# TECHNICAL BULLETIN

Product: TM20-17R/RA, TM14-17R/RA Color Monitors

Purpose of Modification: To eliminate an input switching problem, where the front Panel LED's indicate the input has switched, but the signal is not appearing on the monitor.

Fig.1

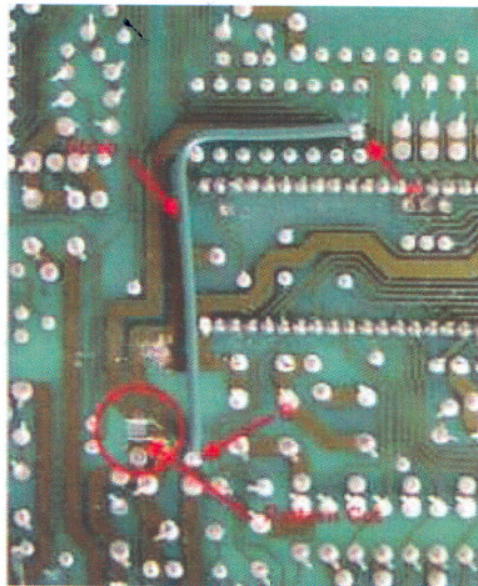
1. Remove C807 on the Video Board.
2. Cut the printed circuit on the A-side (component side) of the board as shown with a red circle and arrow in Fig. 1 below.
3. Cut the printed circuit on the B-side (clad side) of the board as shown with a red circle and arrow in Fig. 2 below.
4. Add a jumper wire on the B-side of the board between the thru-holes of the printed circuit, as indicated with 3 arrows and green wire in Fig. 2 below.
5. Attach a new capacitor (C807: P/N EEC S5R5H224)
